Request for Additional Information: Section 117(3) of the Maritime Area Planning Act 2021

Re: EirGrid plc
Maritime Usage Licence Application Reference: MUL240010

MUL240010 – EirGrid PLC

Image 1: Resubmitted GIS data – 22.12.2025

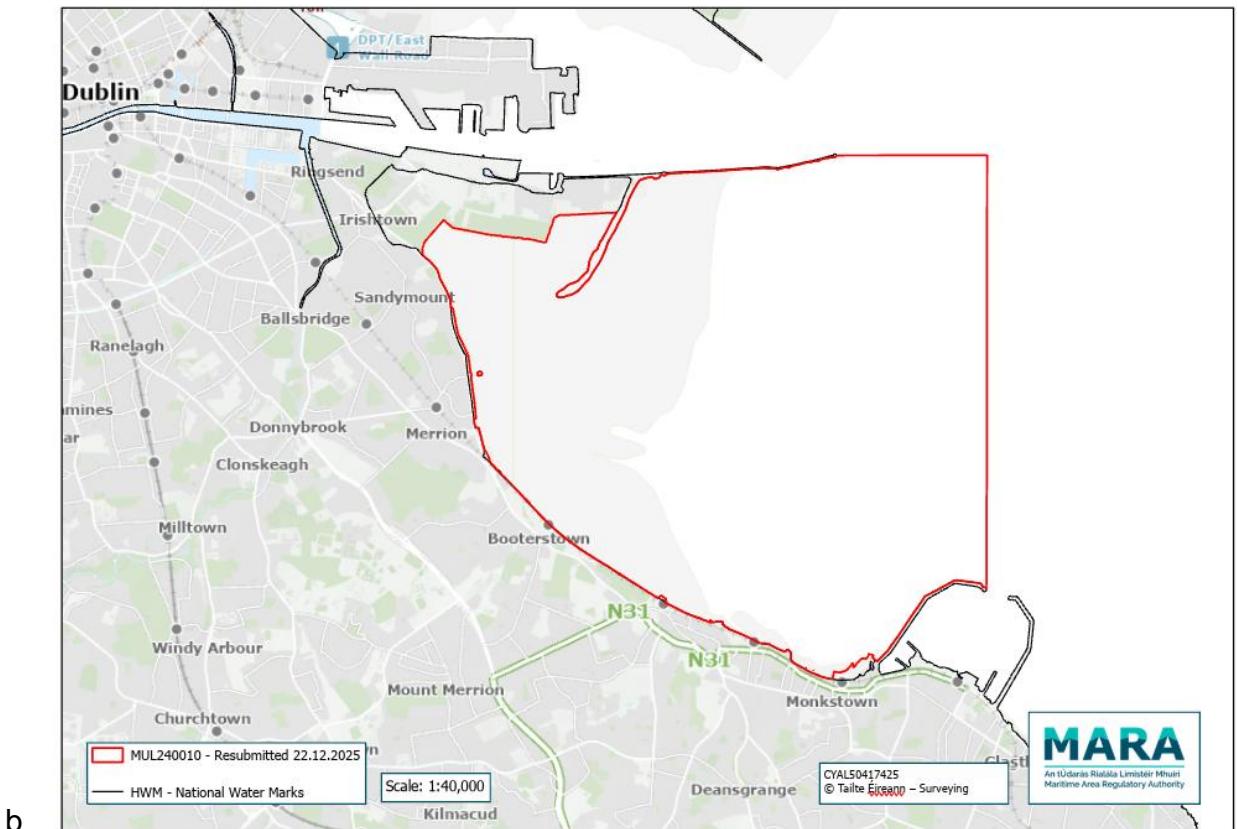
The GIS files re submitted have areas '**Area A**' drawn, which correspond to the Map Title: "**Proposed MUL Map**", Rev: P05 which depicts the area of site investigation works to inform the engineering design and environmental assessments of a proposed electrical cable circuit crossing Dublin Bay from Blackrock Park to Shellybanks.

1. Revise the map for **Area A** to ensure that the MARA Technical Guidance is adhered to:
 - a. MUL Map:
 - i. The MUL area represents only the footprint of the maritime area that the maritime usage licence will occupy.
 - b. GIS Shapefile:
 - i. The GIS shapefile represents only the footprint of the maritime area that the maritime usage licence will occupy.

Image 2: Resubmitted GIS data – 22.12.2025

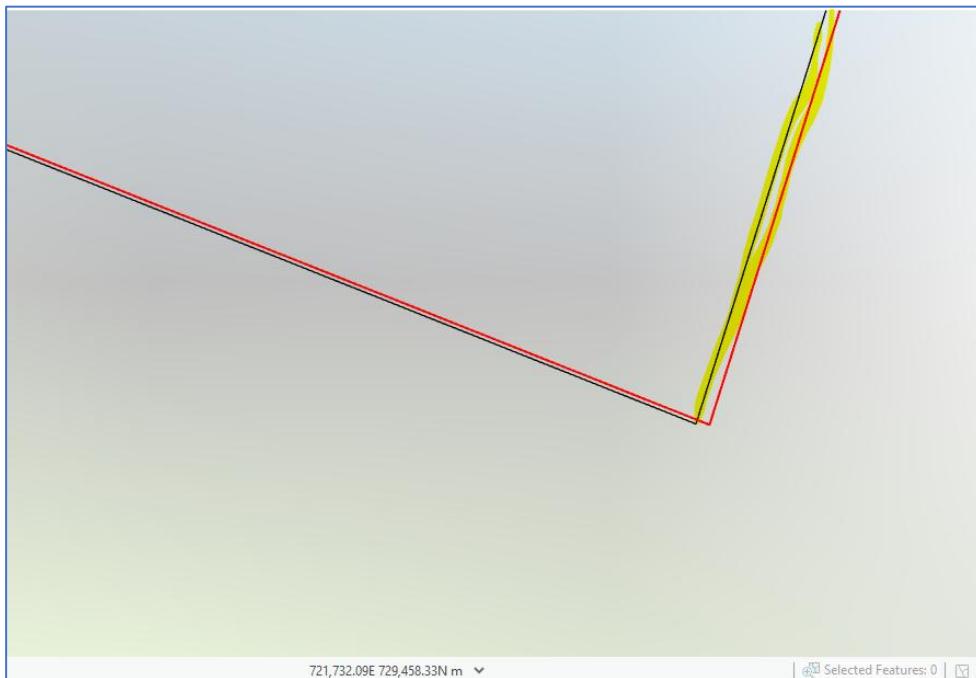
2. **GIS Observations:**
There is a slight shift to the right within the entire GIS dataset. This shift has caused the proposed MUL boundary dataset to traverse onto terrestrial land in places. See Images 2, 3 and 4 below.

3. Please ensure all cartographic maps and GIS data files are updated accordingly and resubmitted to MARA.
